Interactive comment on “A geophone-based and low-cost data acquisition and analysis system designed to microtremor measurements” by Ozkan Kafadar

Received and published: 15 July 2020

Fig. 9. The obtained H/V spectral ratios of recorded data by a) GeoBox b) MicDAC.

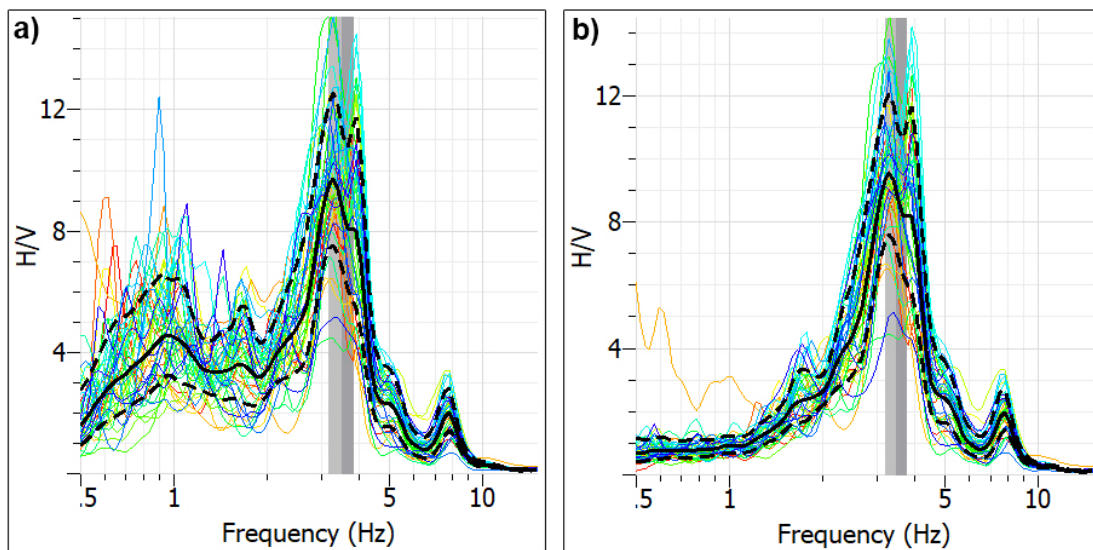
Comment 2: Figure 9: substitute “H/V spectrum ratios” with “H/V spectral ratios”.

Comment 3: Figure 9: there is a perfect match between H/V spectral ratios obtained from data recorded by GeoBox and MicDAC above 2 Hz. On the other hand, below 2 Hz the H/V functions significantly differ each other. Could you explain why? Is this difference due to the different quality of sensors for frequencies below 2 Hz? Please, justify this possibly with the help of an additional figure if necessary.

Reply 2: Thank you very much for your suggestion. I used the “spectral” term instead of the “spectrum”.

Reply 3: Thank you very much for your suggestion. The reason of the difference at frequencies below 2 Hz is that the GeoBox uses an electronic circuit board to obtain a flat band wider than the natural band of the geophone and moves the eigen-frequency to lower value. In this way, it can obtain better sensitiviyy at lower frequencies. I briefly explained the reason of amplitude difference of H/V curves at frequencies below 2 Hz in the last paragraph of Section 3.3
